AKH FASHIONS LTD (EXTENSION)

133-134, Hemayetpur, Savar, Dhaka

15 December 2024

Observation 2: Water ponding on roof slab (Finished Goods Storage Building).

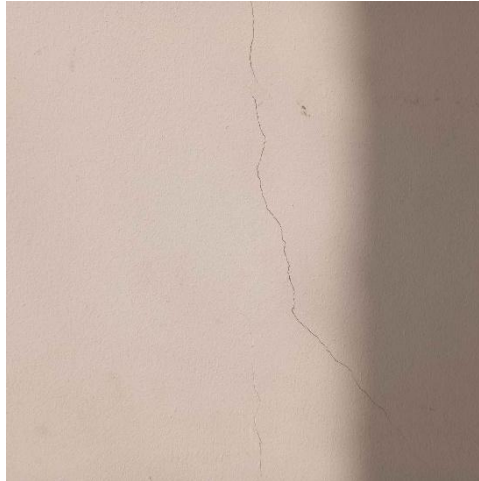
Description: Water ponding was found on the roof slab. The building engineer is required to improve the drainage system on the roof slab.

2.		Carry out the suggested remedial works.	within 6 months
3.	Water ponding on roof slab (Finished Goods Storage Building)	The building engineer is required to improve the drainage system on the roof slab.	within 6 months

Observation 3: Crack on brick wall surface (Finished Goods Storage Building).

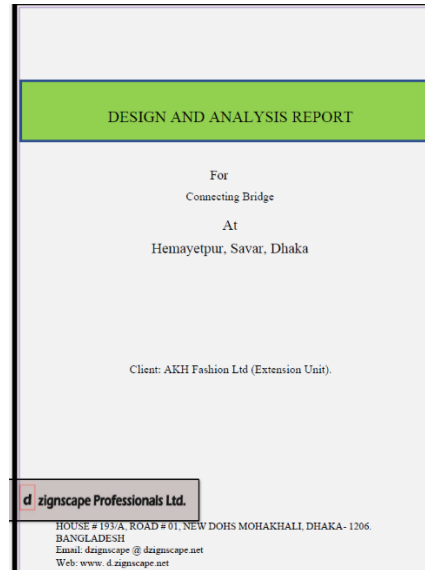
Description: A crack was found on the brick wall surface at the south stair. The building engineer is required to check the reason of crack and repair it with suitable method.

4.	Crack on brick wall surface (Finished Goods Storage Building)	The building engineer is required to check the reason of the crack and repair it with suitable method.	within 6 weeks

Observation 4: Holes on floor beam (Finished Goods Storage Building).

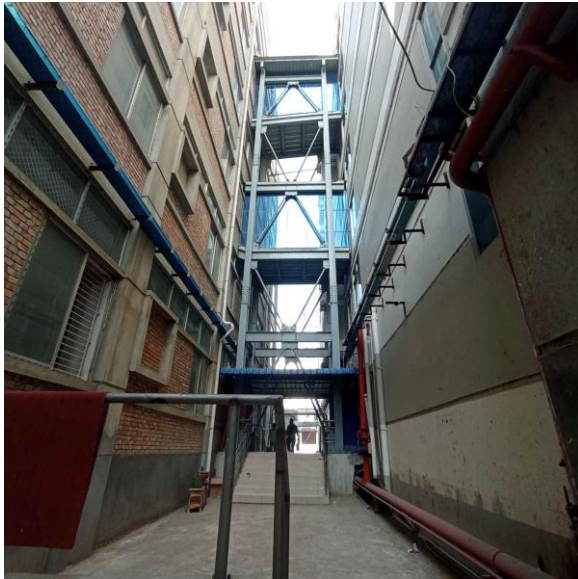
Description: Holes were observed on the floor beam (periphery south side). The building engineer is required to check the effect of holes and if required repair the hole with a suitable method.

5.	Holes on floor beam (Finished Goods Storage Building)	The building engineer is required to check the effect of holes and if required repair the hole with a suitable method.	within 6 weeks

Observation 5: Lack of information in the design report. (Connecting bridge).

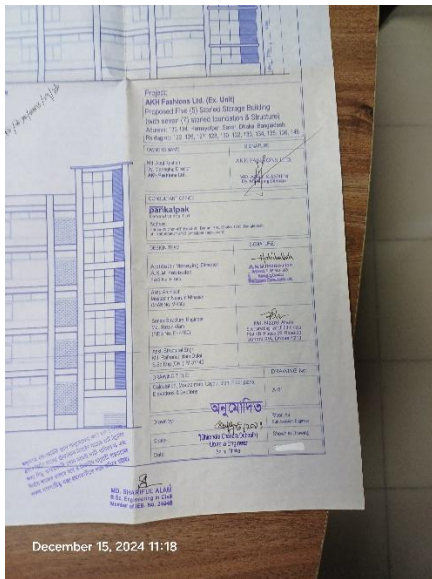
Description: The framing system is not defined (OMRF/IMRF/SMRF). No connection adequacy check is included. Also, the foundation adequacy check is not provided properly. The building engineer is required to update the design report and submit it to RSC for review.

6.	Lack of information in the design report. (Connecting bridge)	The building engineer is required to update the design report and submit it to RSC for review against lateral forces.	within 6 weeks
